From: Abigail Lovett
Sent: Wed, 25 Jun 2025 09:58:12 +1200
To: Ryan Hodgson
Cc: Ash Rabel
Subject: Re: FW: [External] Groundwater Monitoring APP-20222295

I am needing a third opinion regarding groundwater monitoring for Blue Sky Meats site at Morton Mains, Southland. This is a legacy consent application which was lodged over 3 years ago to replace numerous resource consents at the meat works site including waste discharges to land. This application has been stuck for a long time due to differences of opinion between the Council's technical reviewers (Stantec) and the Applicant's technical team (Mitchell Daysh and PDP). The main point of concern for the Applicant is whether there is a need to install 5 additional monitoring bores (above the current 7) to assess groundwater quality as recommended by Stantec. This would be expensive, and the Applicant believes it will also be unnecessary. The Applicant has also since offered to monitor tile drains throughout the site instead of adding more monitoring bores, and to swap one monitoring bore out for a different one in a slightly different area as detailed in the email below.

Figure 2-4: Application areas and soil types for both summer (third party land) and winter (BSM land)³

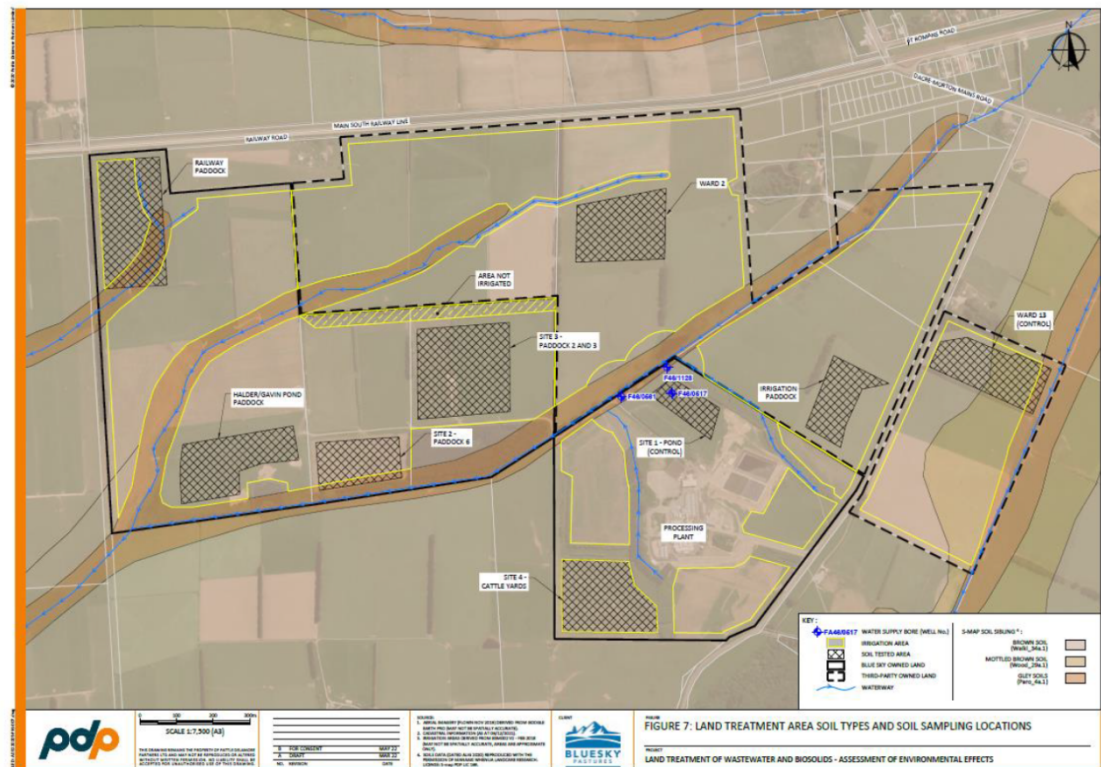
So, I would request that the applicant provides a clear map showing:

- property boundaries (as below)
- irrigation areas (as below)

- surface watercourses (as below)
- groundwater contours (as per alternative map)
- existing GW monitoring bores (as per alternative map)
- proposed new GW monitoring bore (as per alternative map)
- proposed surface water monitoring sites

I have provided an example basemap from their reporting.

They would just remove the soils information and add the surface water and groundwater info.

Once I receive a map I would be able to confirm the suitability of the surface water and groundwater (bore) monitoring sites.
